Addendum 02

PROJECT: EACS New Haven Primary, Leo Elementary and Cedarville Lighting Replacement
1445 Berwick Lane, New Haven, Indiana 46774 (New Haven)/
14811 Wayne Street, Leo, Indiana 46765 (Leo)/
12225 Hardisty Rd, Fort Wayne, Indiana 46845 (Cedarville)

PROJECT #: 23085.00

SHEET NUMBER:
A2.1

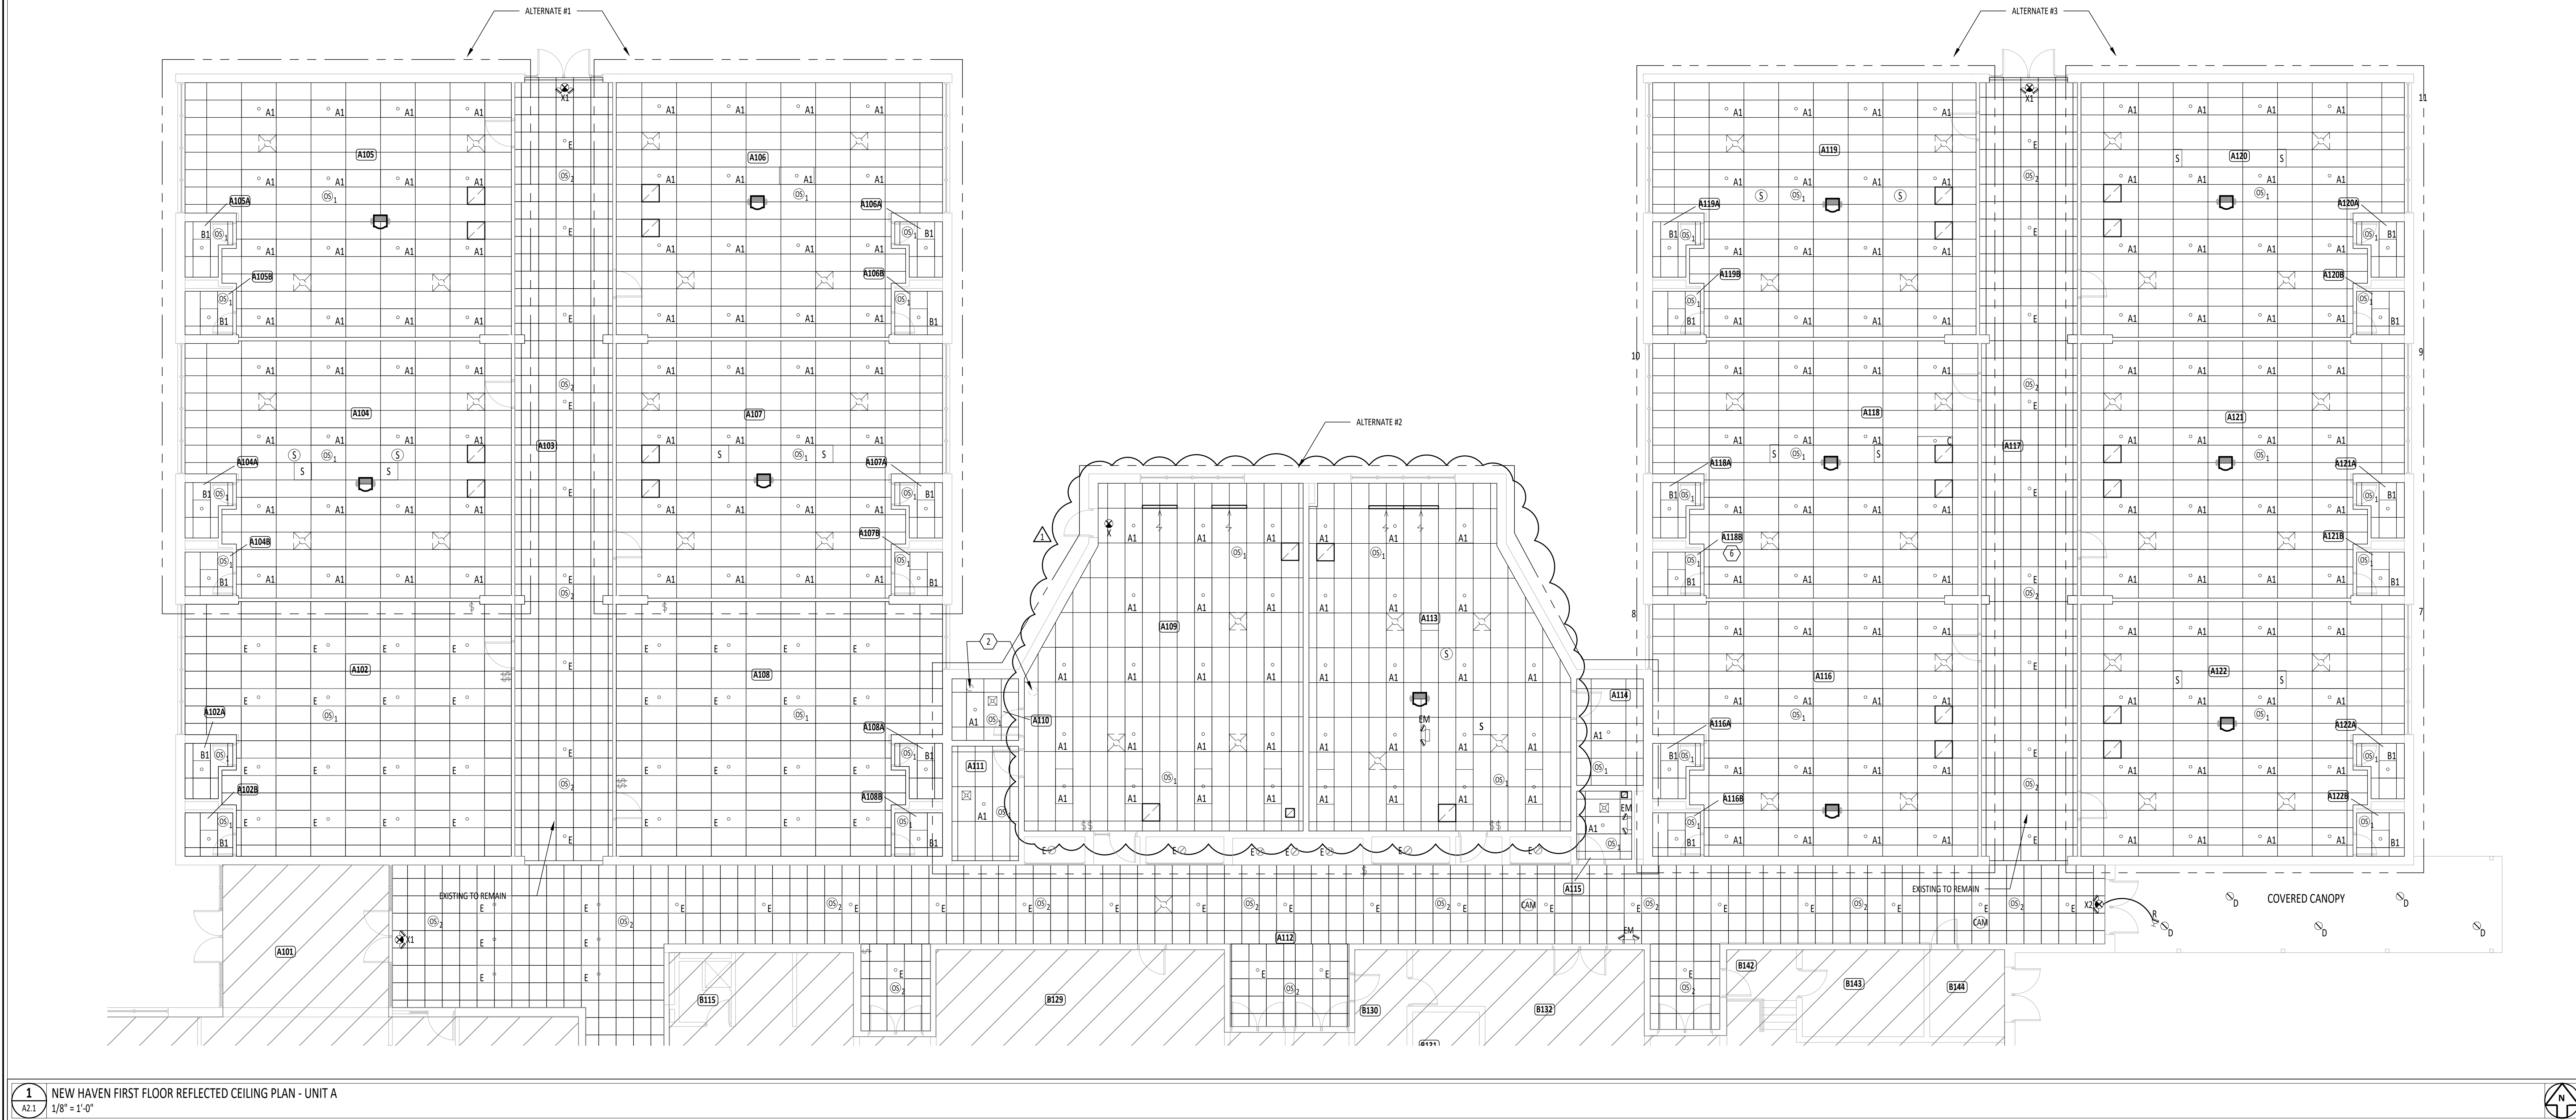
1. Drawing Sheet A2.1 New Haven – First Floor Reflected Ceiling Plan – Unit A: Detail 1
New Haven First Floor Reflected Ceiling Plan – Unit A: Alternate #2: New ceiling grid shall be 2' x 4' in lieu of 2' x 2'.
2. Drawing Sheet A2.3 New Haven – First Floor Reflected Ceiling Plan – Unit C: Detail 1
New Haven First Floor Reflected Ceiling Plan – Unit C: Alternate #2: New ceiling grid shall be 2' x 4' in lieu of 2' x 2'.
